Input Data

Plan Amendment

Figure 1: Added lanes between version 8.3 and 8.3.1.

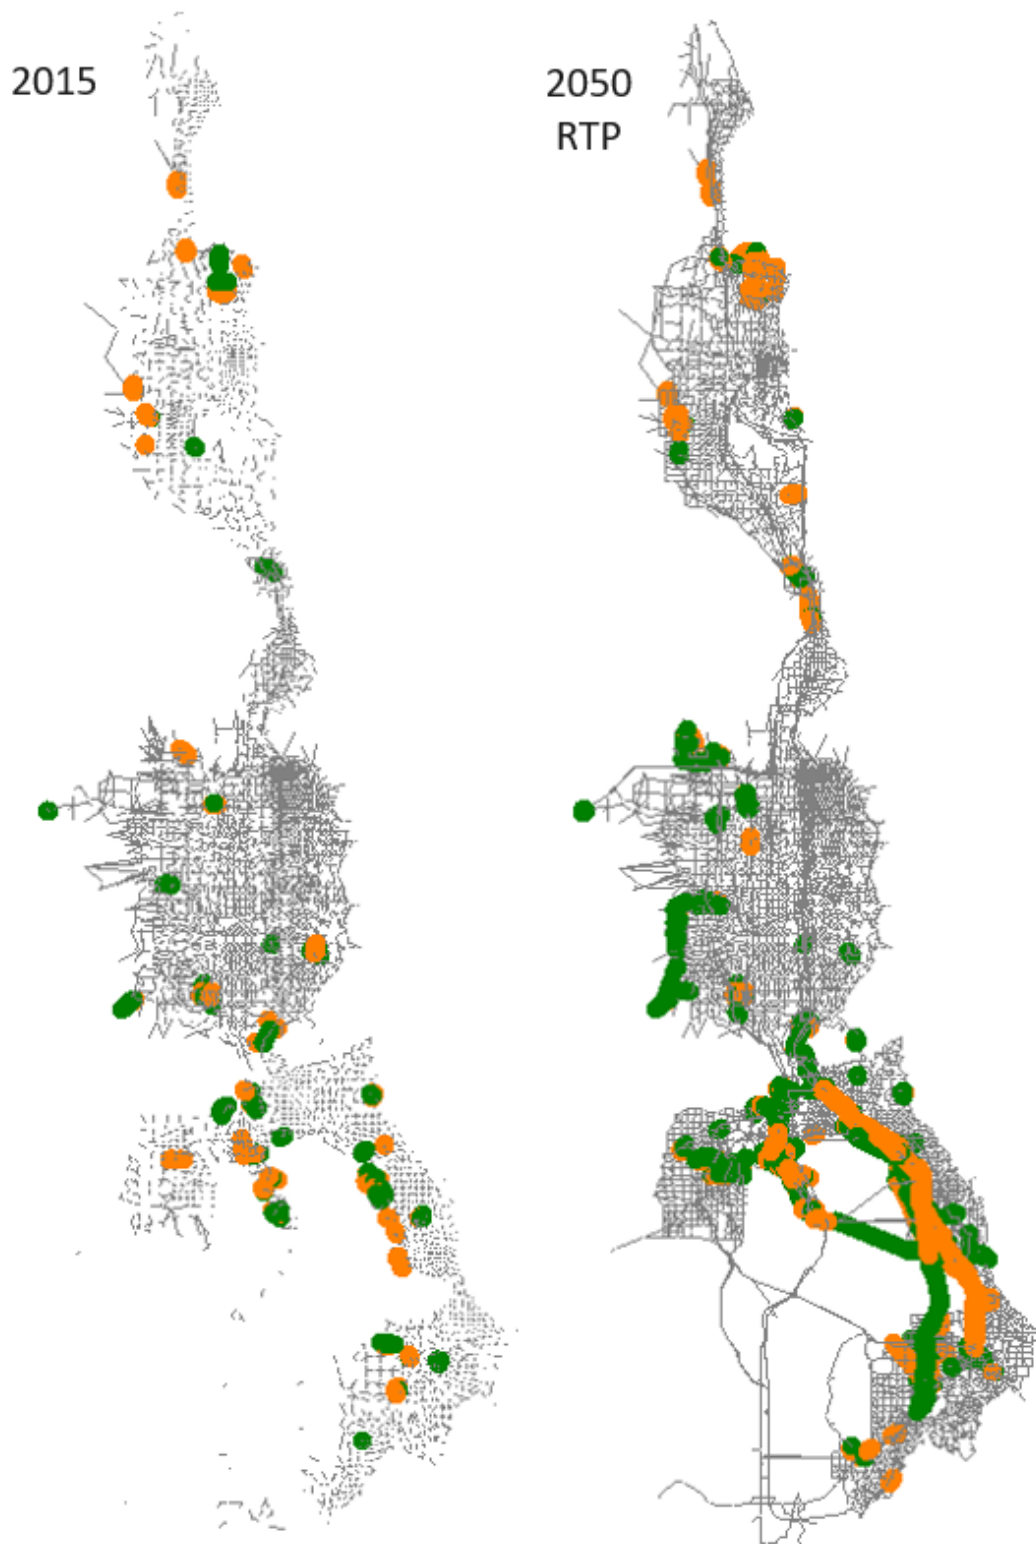
The highway network was updated in the MAG and WFRC areas to reflect the first round of Regional Transportation Plan (RTP) amendments. Additional edits were made in the MAG area to conform with more recent project clarification. The changes to the input highway network are significant, particularly in Utah County, and would most likely affect the travel model's output. Projects in and around areas of high change may want to do sensitivity tests to better understand the impact that these input network changes may have had on project-level decisions. Figure [1](#) shows where lanes were added (green) or were taken away (orange) between versions 8.3 and 8.3.1 highway networks.

Figure 1: SR 201 connection externals.

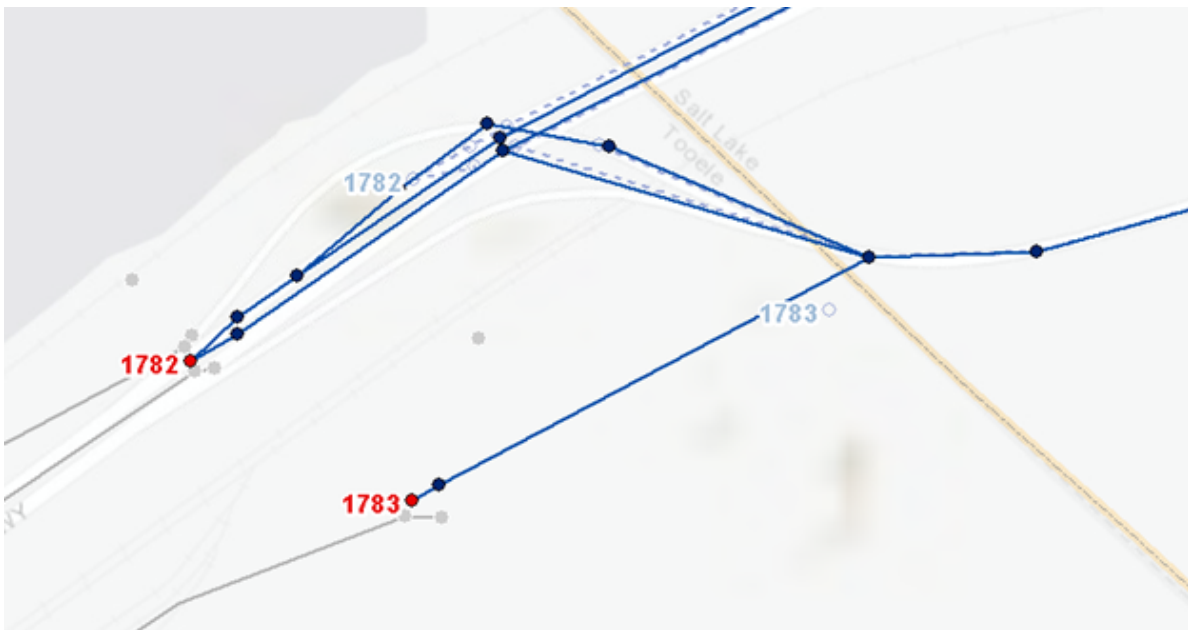
The highway network was modified at the Salt Lake, Tooele County boundary to provide an independent connection to SR 201 at external 1783. (Note external 1783 existed in the version 8.3 network as a place holder and was not connected to the network in that version.) Externals 1782 and 1783 were moved to improve the connection between the Wasatch Front and USTM travel models. The connecting highway links were also modified to accommodate this change.

External 1783 is connected to the highway network via a high-speed divided highway (FT=14) beginning in the 2030 fiscally-constrained plan year. In this year, external volume forecasts also begin for external 1783. Prior to 2030, external 1783 is unconnected to the scenario network and the external volume is zero.

Figure 2: Average weekday traffic volumes for externals 1782 and 1783.

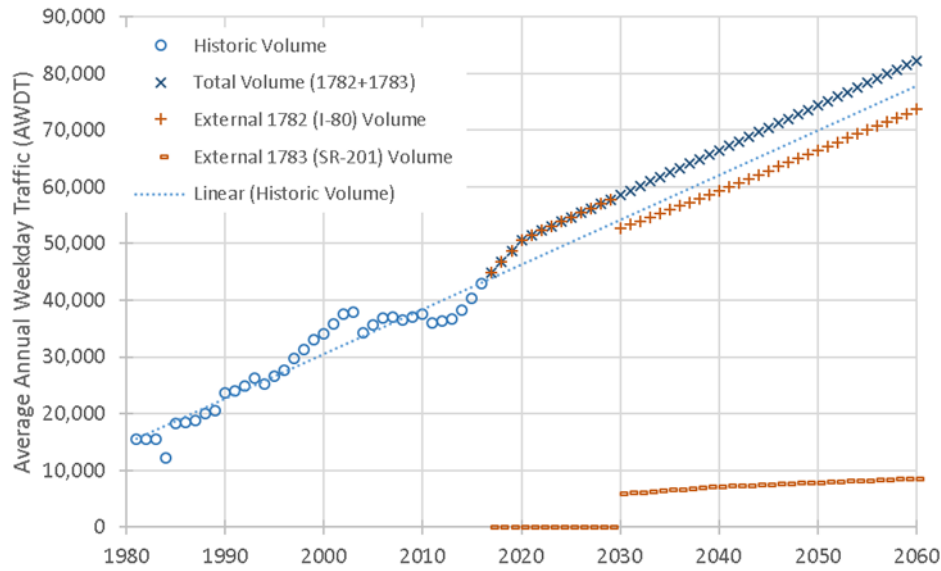
8.3 volume was then divided between the two externals based on information from the Utah Statewide Travel Model (USTM) and professional judgement. The average weekday, single-unit and combo-unit factors for external 1782 were brought up to date with the most current information from the master segment shapefile in the model input folder:

- Average Weekday Factor = 1.057 (was 0.980)
- Single-unit Truck Factor = 7.6% (13%)
- Combo-unit Truck Factor = 9.8% (was 10%)

While the forecast AADT is identical to version 8.3, the change in weekday factor increased the input volume into the Wasatch Front model space by roughly 6%. The relative share of these trips also changed with significantly fewer medium trucks and more passenger cars. The share of heavy trucks stayed about the same. The weekday and truck factors for external 1783 were set to be equal to external 1782.
